## **Thanet Extension Offshore Wind Farm**

Appendix 22 to Deadline 6 Submission: Applicant's  
Responses to the Examining Authority's Third  
Written Questions – EXQ3

Date: May 2019

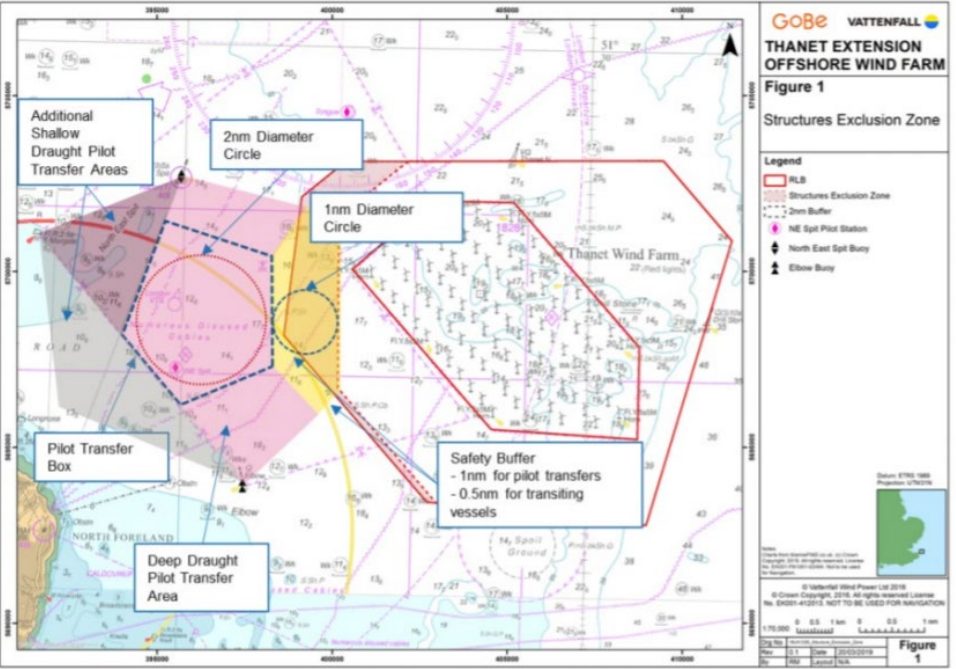
PINS Question number:	Question is addressed to:	Question:	Applicant's Response:
	(MCA); Trinity House (THLS)	<p>the current route between the TOWF and the Kent coast is not designated as a 'sea lane' in the meaning attributed by NPS EN-3. Further in [REP5-18] at point 43, the Applicant makes the case that being outside harbour limits, the area of routes surrounding the TOWF <i>"is better described as an area of open sea."</i></p> <p>In its D5 submission, MCA [REP5-063] argues that the <i>"...area of sea to the west of the existing Thanet windfarm...is not an IMO designated routing measure" but goes on to state "...in an operational sense, the area of sea should be treated as a recognized sea lane" and that "there is no formally designated or charted inshore route or route immediately to the north of the project. There is nothing in the Pilot Books to indicate that (either) is an important route to be followed when route planning..."</i></p> <p>In the [REP4-034] PLA D4 submission</p>	<p>Barker in particular of THLS has noted the area of sea to be an area of general navigation. The Applicant concurs with this view and does not consider the routes to be formal sea lanes, nor understands there to be any existing proposals in place to designate the area as a sea lane or implement any formal routing measures.</p> <p>The Applicant notes that the jurisdiction of the PLA harbour limits are as recorded within charts and previous submission, and that the PLA jurisdiction does not extend to the inshore route area. In this context by being outside of the harbour limits (PLA statutory and competent harbour authority area boundaries) this is outside of the PLA jurisdiction and lies within an area of open sea that is under MCA responsibility (and THLS as relates to aids to navigation).</p>

PINS Question number:	Question is addressed to:	Question:	Applicant's Response:
		<p>Appendix 1: Anatec Review of Evidence Figures 8.3 and 8.4, this inshore route is clearly shown as one of the 3 primary approaches to the Thames Estuary prior to and after any WF construction in the estuary.</p> <p>Would the IPs please clarify for the avoidance of doubt:</p> <p>a) whether MCA intends “the area of sea” in its [REP5-063] submission referred above in both instances to mean the space used for general navigation, transit by commercial vessels and pilot transfer between the southerly extent of VTS control as shown on charts and the NE Spit Racon buoy; and</p> <p>b) whether THLS agrees with the Applicant that being outside the controls exercised within the limits of Port of London Authority, the area of sea including around the TOWF should be described as “an area of open sea” as argued by the Applicant in the [REP5-018] submission; and</p>

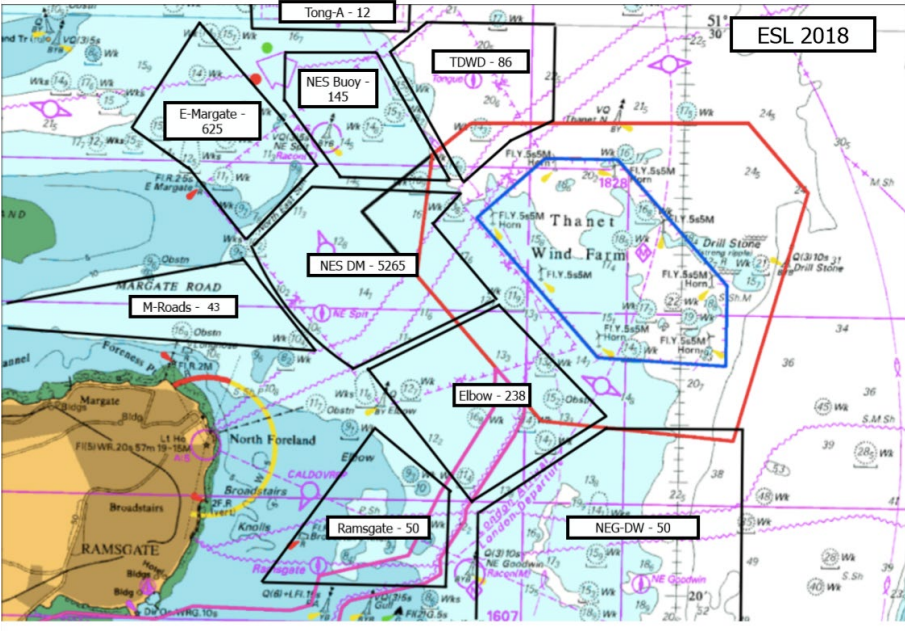
PINS Question number:	Question is addressed to:	Question:	Applicant's Response:
			in particular.
3.12.9.	The Applicant	<p><b>Implications of pilot station relocation if needed</b></p> <p>In [REP3-004] response to point 4 of [REP2-048] from Sunk User Group the Applicant refers back to [REP2-011] Appendix 4 to D2 responses which states <i>"The Applicant, at the Pilotage Study Report undertook analysis of the time, distance and cost involved for launches servicing the various stations and this should be used in understanding the commercial impact"</i>.</p> <p>Would the Applicant please clarify with additional detail how this answer and the Pilotage Study report addresses the [REP2-048] point 4?</p>	<p>The Applicant notes that REP3-004 relates to <i>"Deadline 3 Submission -Annex B to Appendix 1: MCZ Chart illustrating Goodwin Sands with relevant projects"</i> which the applicant considers may be an incorrect reference and therefore the applicant is unsure of the appropriate reference.</p> <p>The Applicant notes the reference to the Sunk Users Group – which does not have operational oversight of the NE Spit Study area, that at point 4 of [REP2-048] noted:</p> <p><i>"4) If the NE spit pilot station had to be relocated further seaward, this will unfortunately result in extra costs, not just financially, but also in time, to pilots, and pilot launch transiting times. Being exposed further out to sea, may also have the result of more probable likelihood of unfavourable sea and swell conditions. This could result in more vessels not being served and having to wait considerable time for wind conditions to be in their favour."</i></p> <p>The Sunk User group are simply pointing out that if a pilot station were relocated, then additional cost and operational impacts <u>could</u> occur.</p> <p>The Applicant notes that REP2-011 relates to <i>"Deadline 2 Submission –</i></p>

PINS Question number:	Question is addressed to:	Question:	Applicant's Response:
			<p><i>Appendix 19: Revised Application Document. Doc 2.3 Land Plans (Onshore)– Revision D</i>”, however it is believed that the ExA is referring to the Pilotage Study [ES Volume 4, Annex 10-1] at “Section 3.3 Alternative Pilot Arrangements”, in which analysis is presented on the increase transit time for the pilot launch if pilot boarding were to take place at either the:</p> <ul style="list-style-type: none"> <li>• Option 1: Board pilots to the south of the wind farm, between Ramsgate and North East Goodwin</li> <li>• Option 2: Board pilots near to North East Spit east cardinal, to the west of the wind farm and the Tongue station.</li> </ul> <p>The analysis presented notes that there is no difference in distance if the pilot launch transits to Option 1 and that the launch would have to travel an additional 2.9nm were to travel to Option 2, an additional 7.25 minutes per transfer.</p> <p>It is important to note that the context of the Pilotage Report relates to the PEIR RLB, which was reduced at the western extent for the ES submission to the current RLB, and further reduced as a result of implementing the SEZ. As such comments on “constrained fairways” no longer apply.</p> <p>Further it is the Applicants firm view that there is no need for pilot transfer locations to change as the 2nm plus 1nm has been met for the NE Spit Pilot Diamond, with the SEZ in place, and that most other operational areas for pilot boarding are unaffected by the TEOW.</p>

PINS Question number:	Question is addressed to:	Question:	Applicant's Response:																																	
			<p>However, and despite the Applicants firm view on this matter, specific analysis is presented in response to ExQ 3.12.7. on commercial impact of moving the Tongue pilot diamond, and within ExQ 3.12.10 on relocation of any transfers that could be impacted at Elbow as a result of the TEOW with the SEZ in place.</p>																																	
3.12.10	The Applicant	<p><b>Unadopted risk control: NE Spit pilot boarding operations</b>                      In [REP5-039] the NRAA (revised) at para 172 the Applicant states: <i>'A risk control, identified within the original NRA (Table 22, unadopted risk control No.2) which has not been adopted, is the relocation of the NE Spit Pilot Boarding operations. The Applicant does not consider that the scheme would require any such relocation, as the hazard risk scores assessed in this Addendum NRA demonstrate navigation risk to be acceptable... The Applicant considers that this is confirmed by the introduction of the SEZ, which ensures that the required sea room for pilot transfer would be available. However, if IPs consider that there is a residual concern</i></p>	<p>The Applicant notes the following responses to the ExA Questions:</p> <p>a) The Applicant notes that <i>"NE Spit pilot boarding operations"</i> relates to the whole of the operation NE Spit pilot boarding area noted by ESL (as presented below and at Fig 14, Fig 15 [also below] and Table 5 of REP5-039):</p>

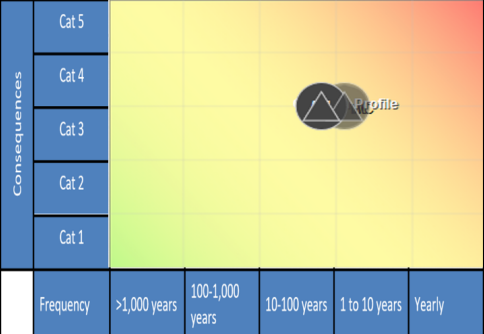
3.12.21	Port of London Authority (PLA); Maritime	<p><b>Additions to the NRAA made at deadline 5</b></p> <p>Would the IPs comment on the recent textual changes in regard to risk assessment made at Deadline 5 to the</p>	<p>The Applicant will respond in due course to Port of London Authority (PLA); Maritime and Coastguard Agency (MCA); Trinity House (THLS); POTL/LGPL and PLA and London Pilot Council (LPC); Thanet Fisherman's Association (TFA); UK Chamber of Shipping (UkCoS); Port of Sheerness Ltd (PSL) responses.</p>

PINS Question number:	Question is addressed to:	Question:	Applicant's Response:
	and Coastguard Agency (MCA); Trinity House (THLS); POTL/LGPL and PLA and London Pilot Council (LPC); Thanet Fisherman's Association (TFA); UK Chamber of Shipping (UkCoS); Port of	NRAA (rev B) [REP5-039]: a) Para 135: Additional Risk Control: Enhanced promulgation of information (redrafted); Shipping and Navigation Liaison Group Terms of reference (redrafted); Post-consent Monitoring (redrafted); Enhanced optimisation of TEOW line of orientation etc (redrafted); Aids to Navigation etc (redrafted); b) Paras 141 to 144 and Table 19: New insertion in rev B; c) Para 145: "...the assessment of cost benefit in the original NRA remains valid." d) Para 146: Summary results of the hazard workshop (New Annex C to Deadline 5 submission) "...ID's 4-18 [sic]...were updated based on IP comments..."; e) Ranked Hazard list (now Table 20) changed to omit columns for individual

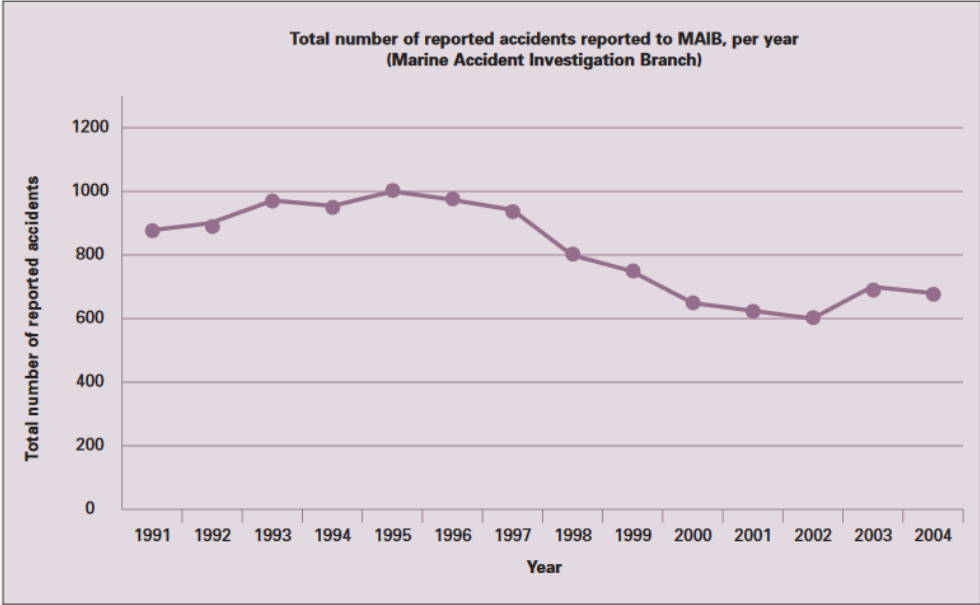
3.12.22	The Applicant	<p><b>Risk scoring detail (NRA ID12 example)</b> In [REP1-008] Applicant's supplementary note on NRA process, in the Property category of this Hazard ID12 "Collision between two large commercial vessels", with the "Most Likely" outcome of this hazard ("<i>low speed collision, likely to be glancing blow, with limited consequence values...</i>") the HAZMAN algorithm produces a score of 5.24 apparently with a 1 in 15 year return rate likelihood compared with a score of 5.92 when the return rate drops to 1 in 10 years.</p> <ul style="list-style-type: none"> <li>• Would the Applicant please explain</li> </ul>	<p>The reasons that a risk score may be lower than may be intuitively anticipated is associated with the matrix, which due to the need to account for all hazard likelihoods (up to greater than a 1 in 1000 year event), uses a logarithmic scale for the categories. The following provides further context with regards the specific matrices used to inform maritime risk assessments.</p> <p>The generation of risk scores is related to the risk matrix, and within the context of the question, it does not matter which specific matrix is used, in that all have common principles, which account for the explanation the ExA are seeking as to why when likelihood is changed, to a level which may be perceived to be significant, this does not appear to significantly change the risk scores.</p> <p>The reason is that risk matrices need to be able to provide for any combination of hazard likelihood and hazard consequence, and when</p>

PINS Question number:	Question is addressed to:	Question:	Applicant's Response:
		<p>how and why this rise in return rate of 50% (10 years instead of 15 years) produces via the algorithm an increase of 12.9% in risk rating.</p>	<p>related to maritime navigation risk assessment risk matrices need to be able to accommodate a range of hazards. The range may be from lower severity hazards that may occur more frequently (typically associated with most likely hazards outcomes), to catastrophic severity hazards which occur less frequently (typically associated with worst credible hazard) outcomes. Risk matrices need therefore to be able to accommodate these polar ranges of hazards on the same risk matrix and do so based on combining of two factors:</p> <ol style="list-style-type: none"> <li>1. The likelihood of a hazard occurring.</li> <li>2. The consequences of a hazard occurring.</li> </ol> <p>For the sake of clarity, it does not matter within the context of generating a hazard score whether it refers to a Baseline, Inherent or Residual assessment of risk, or whether a final score is generated by aggregating individual consequence category (e.g. People, Property, Environment or Stakeholder / Business categories) risk score – it is the matrix that combines the two factors to generate a risk scores.</p> <p>The matrix used for the NRA and the NRA A, is presented below and in terms of being a 5 by 5 matrix, is standard within the industry, and is as used by the PLA for their detailed port wide risk assessment – not as used in the PLA Risk Assessment Proforma (found at <a href="https://www.pla.co.uk/assets/fm197plariskassessmenttemplate.xlsx">https://www.pla.co.uk/assets/fm197plariskassessmenttemplate.xlsx</a>) which is identified as a simple risk assessment proforma.</p>

PINS Question number:	Question is addressed to:	Question:	Applicant's Response:																																					
			<p>The matrix has been annotated with two symbols showing where on the risk matrix (the baseline and inherent likelihood score would fall for) a 1 in 10 year event and a 1 in 15 year hazard with a category 3 – moderate level consequence would geometrically be plotted. It can be seen that in the context of the risk matrix this difference is actually minimal, when considering the full range of likelihoods the matrix needs to accommodate.</p> <div style="display: flex; justify-content: space-around; align-items: center;">
